FAIRFAX COUNTY

STAFF REPORT ADDENDUM

APPLICATION RZ/FDP 1998-LE-055

APPLICANT: Hybla Valley Properties LLC

2 of 7
 PL-200

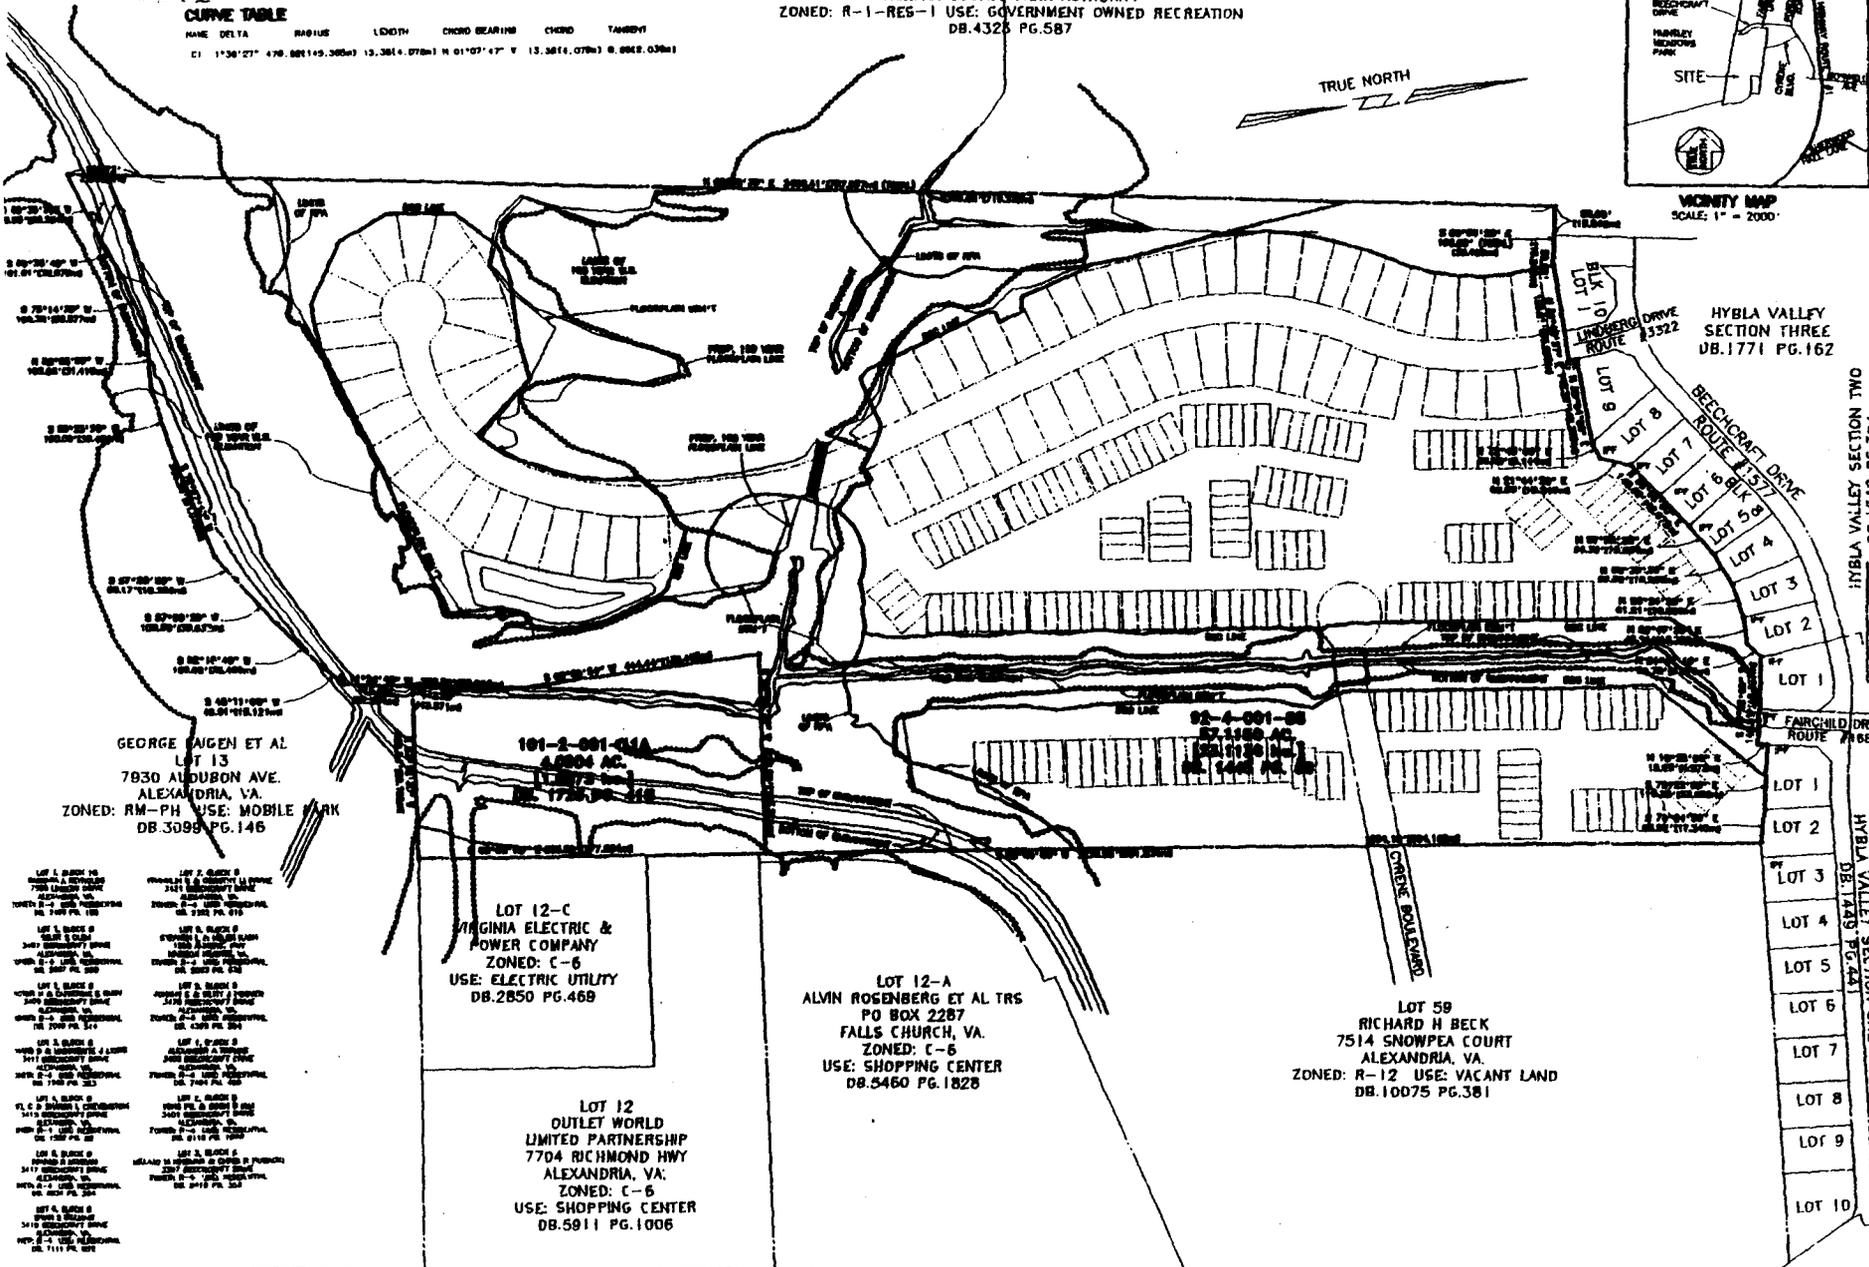
- The proffers explicitly state that all lots will be outside the floodplain; however, it would be desirable for a revised CDP/FDP to be submitted reflecting the approved floodplain easement and the approved RPA boundary that shows all lots outside the floodplain easement; and,

With the exception of a small area near the proposed Lindberg Drive culvert crossing (as noted below), the development plan should be revised such that all private lot areas will be located outside of the 100-year floodplain areas and that no clearing and grading for residential development will occur within such areas. Prior to DPWES approval of the floodplain study, the applicant dealt with this concern by including within the draft proffers a commitment that "all private lots shall be located outside the limits of the final boundaries of the flood plain areas as approved by DPWES." The draft proffers also would provide the applicant with some flexibility to reconfigure or reduce the number of lots during the subdivision and site plan review processes, recognizing that there may be a need for a proffer condition amendment application if these changes were to deviate too much from an approved development plan. In addition, the draft proffers stated: "in the event the final approved flood plain limits are different from that shown on the CDP/FDP the corresponding limits of clearing and grading on the CDP/FDP shall be adjusted accordingly." Now that the floodplain study has been approved, the simplest and most effective way to deal with this issue would be to revise the development plan as recommended above. If the applicant chooses not to do this, the draft proffers should be clarified to ensure that no portion of any private lot (with the exception noted below) would be located within a 100-year floodplain area (either existing or post-development). Further, the phrase "shall be adjusted accordingly" should be clarified.
